COUNTY OF HENRICO  
VIRGINIA

## INTER-OFFICE MEMORANDUM

To: Planning Office Subject: POD2023-00206: Helios  
Henrico County Police Division,  
From: Community Services Unit Date: June 8, 2023

POD2023-00206

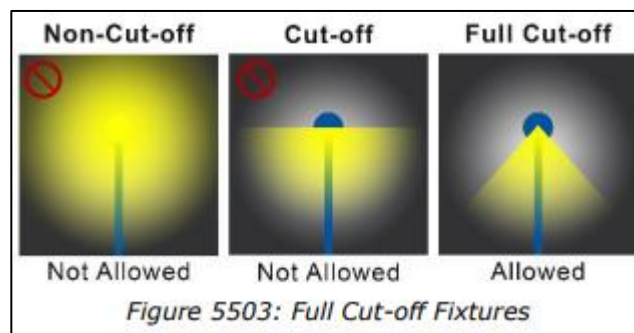
All light fixtures need to be full cut-off. See Figure 5503: Full Cut-off Fixtures below:
